EXISTING TECHNICAL SPECIFICATIONS AND BASES
UNIT 3

PROPOSED TECHNICAL SPECIFICATIONS AND BASES
UNIT 3

CHANGES TO TS 3.4.8.3.1 PAGES WHICH WERE PREVIOUSLY REQUESTED IN
AMENDMENT APPLICATION NO. 97 (PCN-358) DATED DECEMBER 20, 1991
AND ARE BEING REQUESTED IN PCN-359

SAN ONOFRE UNIT 3

FIGURE 3.4-2
SONGS 3 HEATUP RCS PRESSURE/TEMPERATURE
LIMITATIONS FOR —4— 8 EFY
Normal Operation

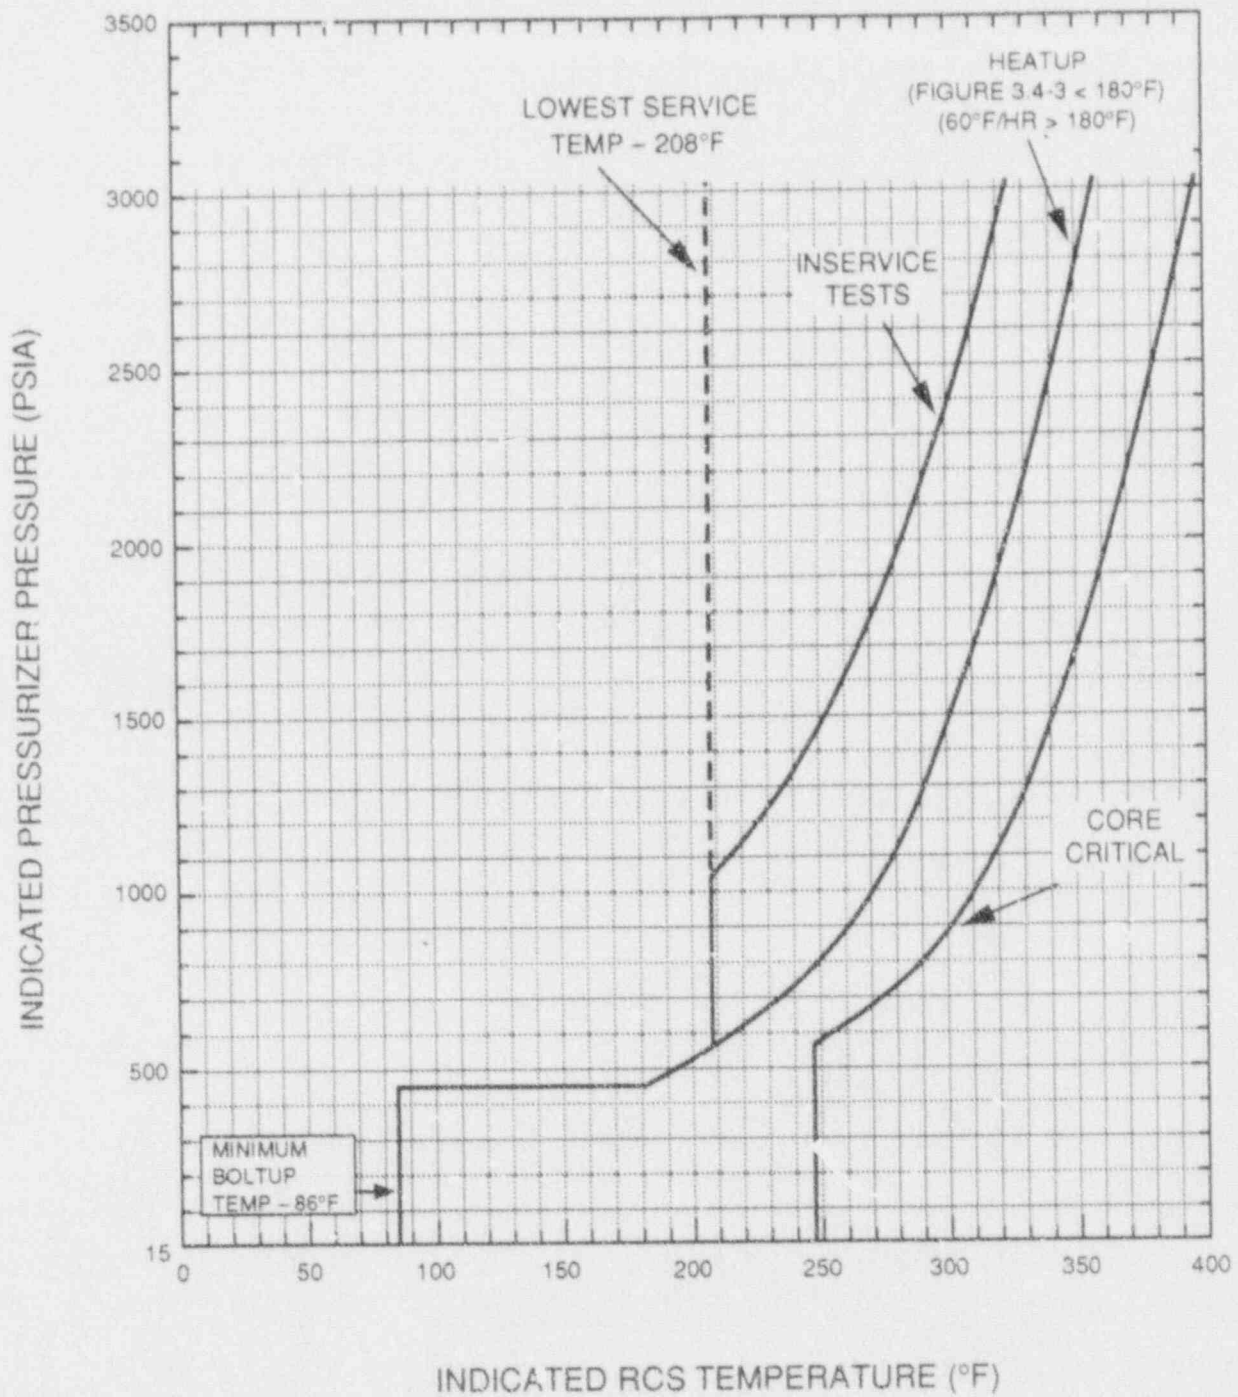
- a. A maximum heatup as specified by Figure 3.4-3 in any 1-hour period with RCS cold leg temperature less than ~~±53~~ 180°F. A maximum heatup of 60°F in any 1-hour period with RCS cold leg temperature greater than ~~±53~~ 180°F.
- b. A maximum cooldown as specified by Figure 3.4-5 in any 1-hour period with RCS cold leg temperature less than ~~±26~~ 175°F. A maximum cooldown of 100°F in any 1-hour period with RCS cold leg temperature greater than ~~±26~~ 175°F.
- c. A maximum temperature change of 10°F in any 1-hour period during inservice hydrostatic and leak testing operations above the heatup and cooldown limit curves.
- d. A minimum temperature of 86°F to tension reactor vessel head bolts.

NOTE: A MAXIMUM HEATUP RATE OF 60°F/HR IS ALLOWED
AT ANY TEMPERATURE ABOVE 153°F 180°F

FIGURE 3.4-3

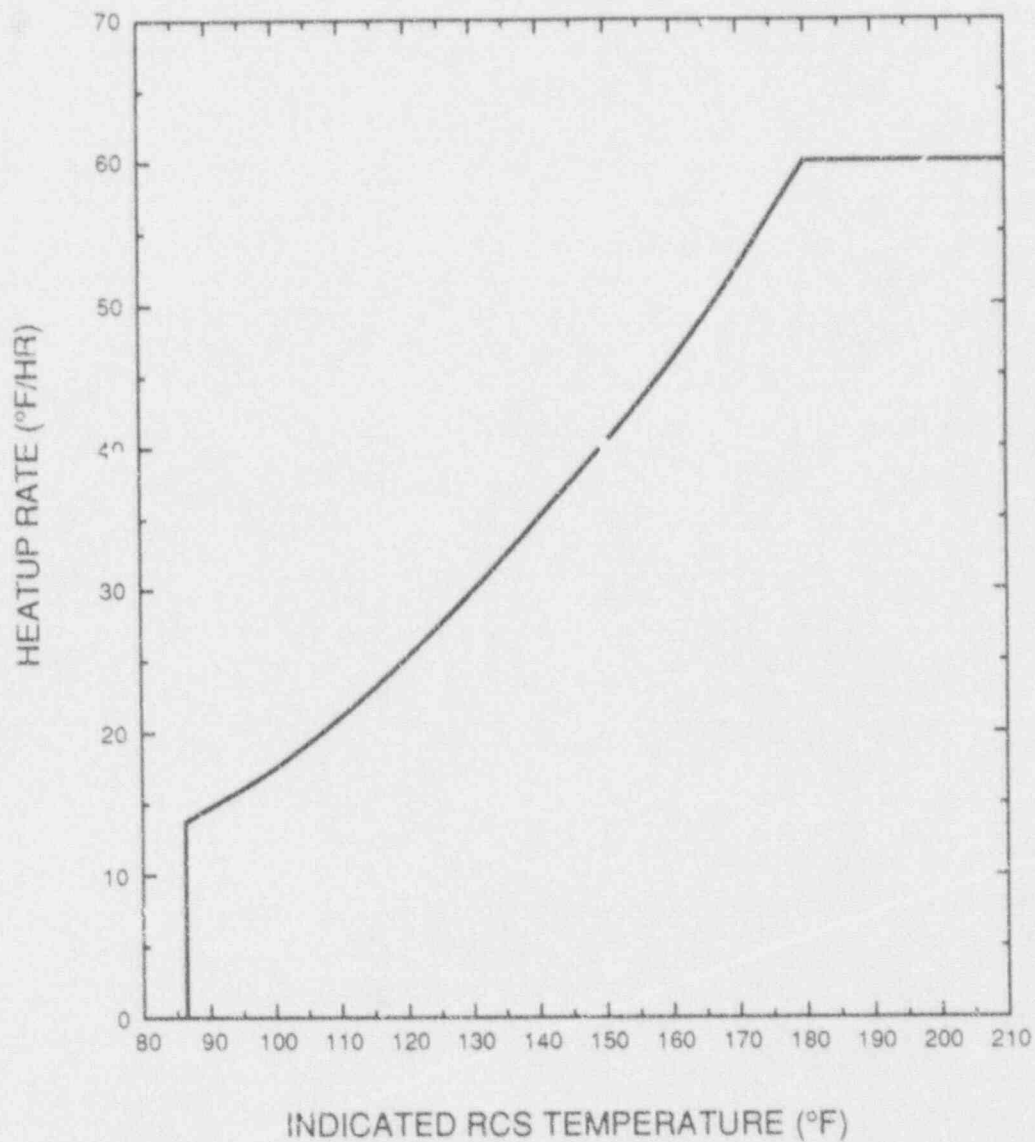
SONGS 3 RCS PRESSURE/TEMPERATURE LIMITS
MAXIMUM ALLOWABLE HEATUP RATES (—4— 8 EFPY)
Normal Operation

FIGURE 3.4-4

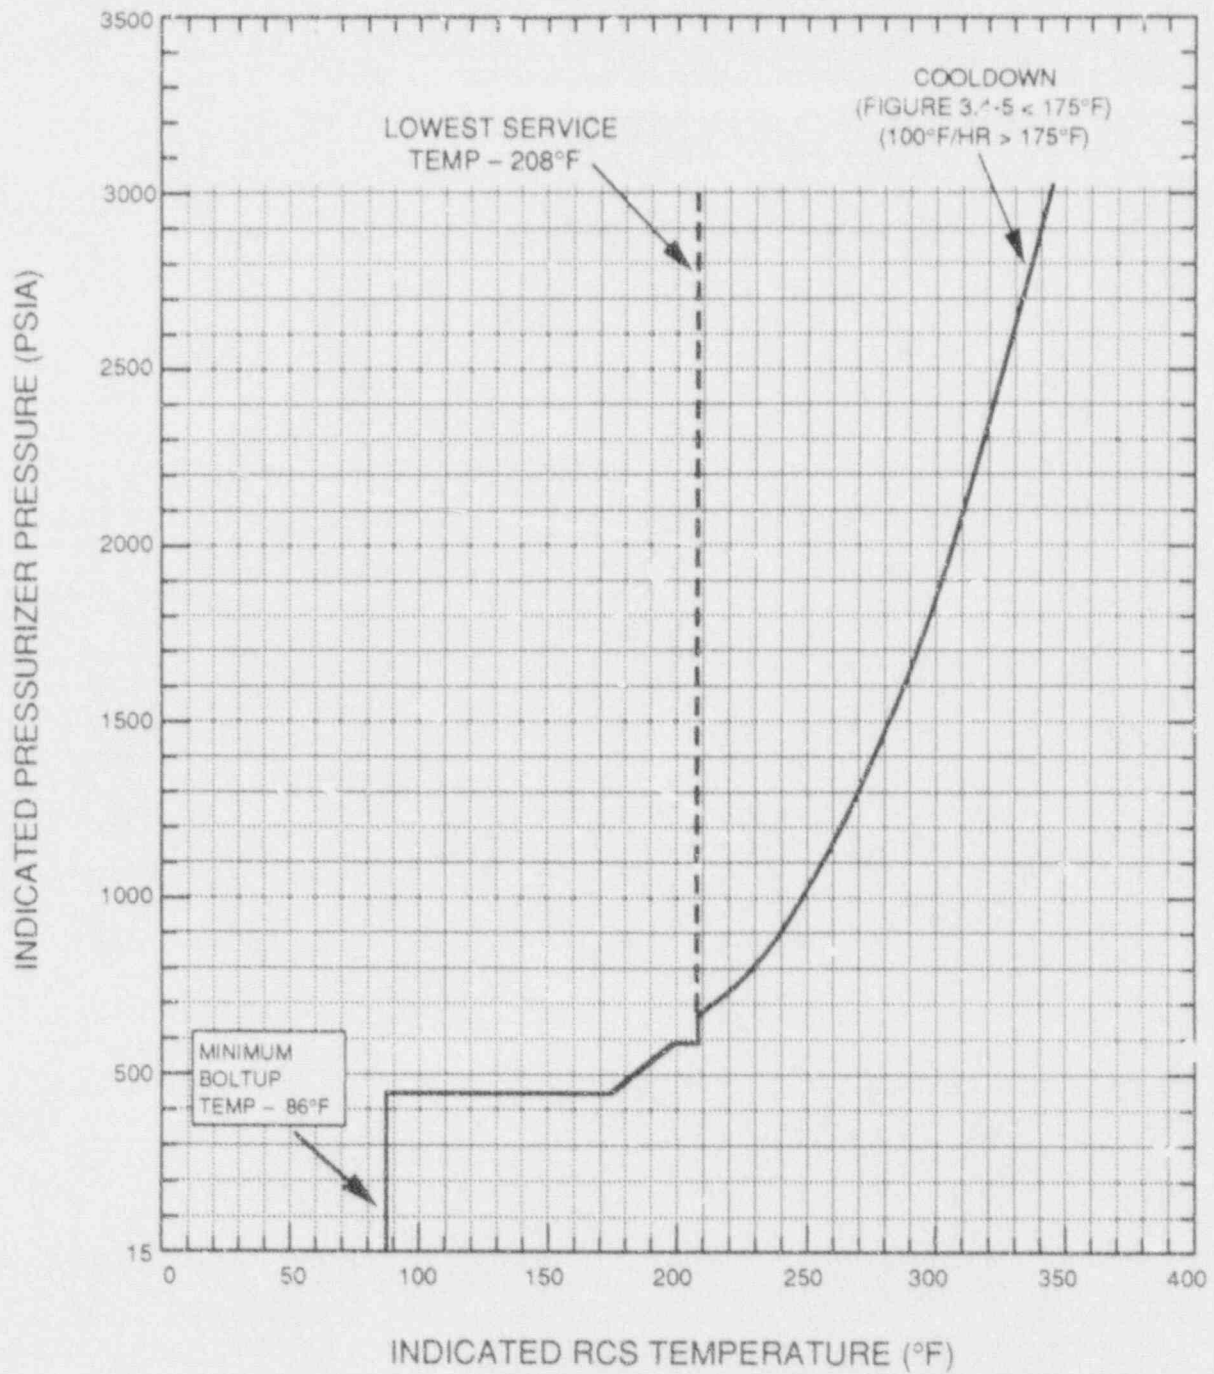
SONGS 3 COOLDOWN RCS PRESSURE/TEMPERATURE
LIMITATIONS FOR —4— 8 EFPY
Normal Operation

NOTE: A MAXIMUM COOLDOWN RATE OF 100°F/HR IS ALLOWED
AT ANY TEMPERATURE ABOVE 175°F

FIGURE 3.4-5

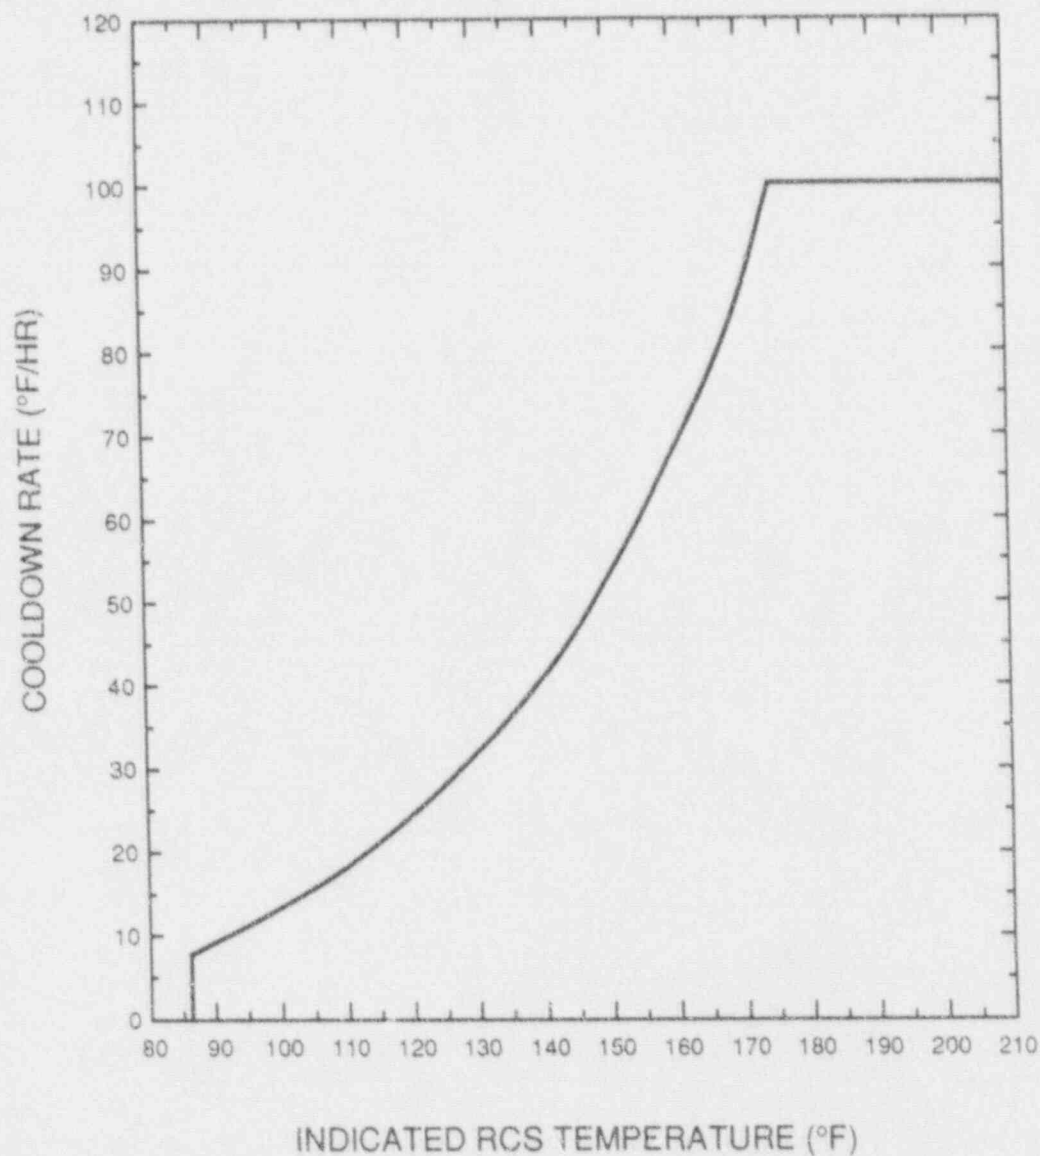
SONGS 3 RCS PRESSURE/TEMPERATURE LIMITS
MAXIMUM ALLOWABLE COOLDOWN RATES (—4— 8 EFY)
Normal Operation

FIGURE 3.4-6

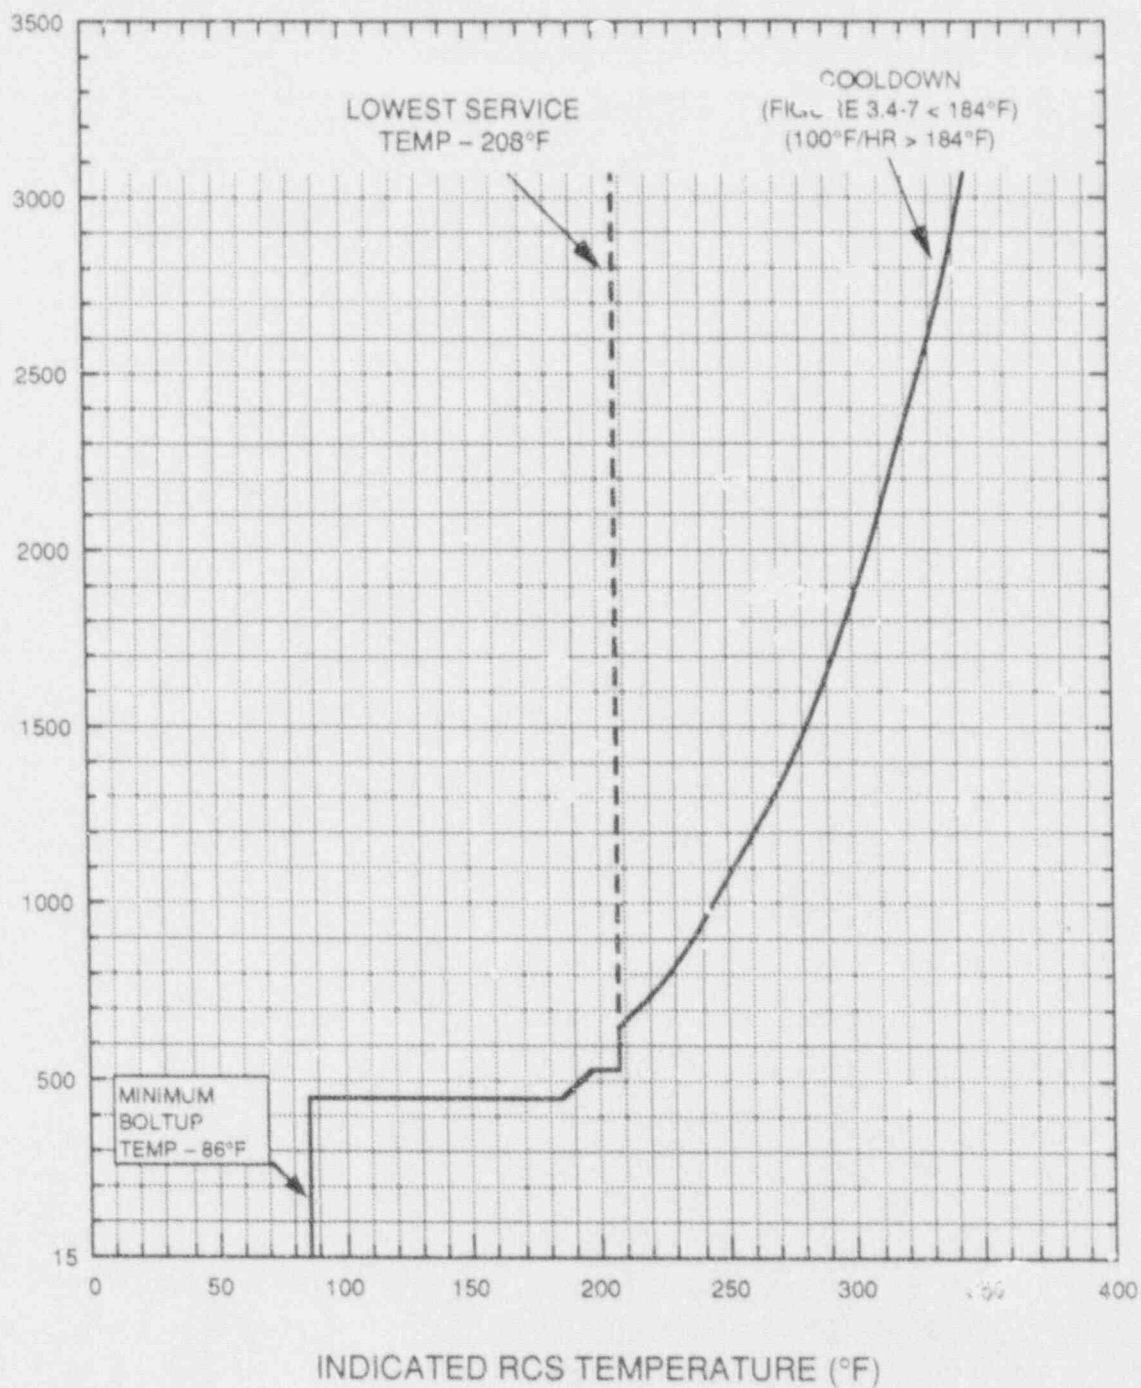
3.4.8.1 With the reactor vessel head bolts tensioned*, the Reactor Coolant System (except the pressurizer) temperature and pressure shall be limited in accordance with the limit lines shown on Figures 3.4-2, 3.4-3, 3.4-4, and 3.4-5, 3.4-6, and 3.4-7 during heatup, cooldown, criticality, and inservice leak and hydrostatic testing with:

SONGS 3 COOLDOWN RCS PRESSURE/TEMPERATURE
LIMITATIONS FOR 8 EFY
Remote Shutdown Operation

NOTE: A MAXIMUM COOLDOWN RATE OF 100°F/HR IS ALLOWED
AT ANY TEMPERATURE ABOVE 184°F

FIGURE 3.4-7

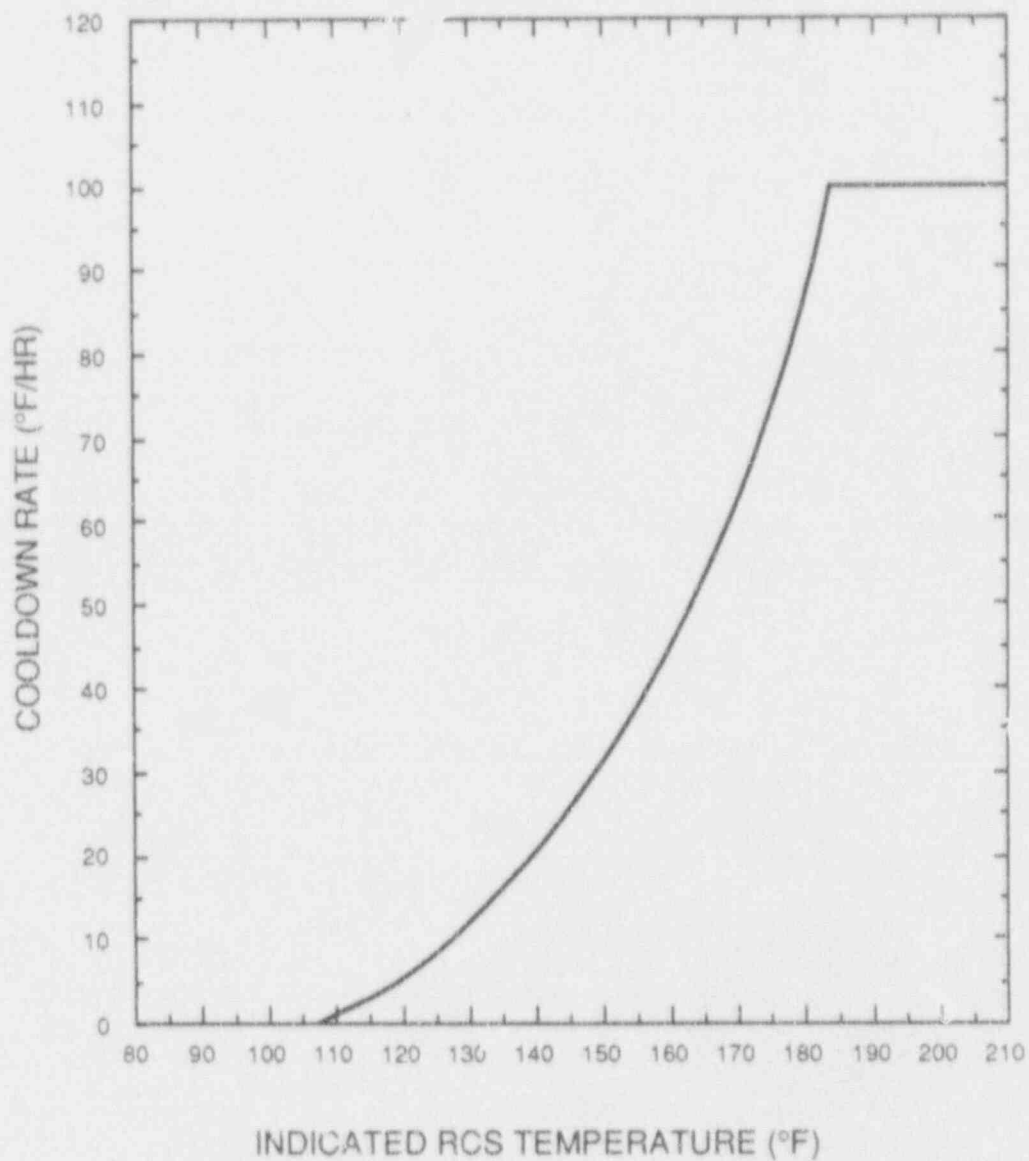
SONGS 3 RCS PRESSURE/TEMPERATURE LIMITS
MAXIMUM ALLOWABLE COOLDOWN RATES (8 EFY)
Remote Shutdown Operation
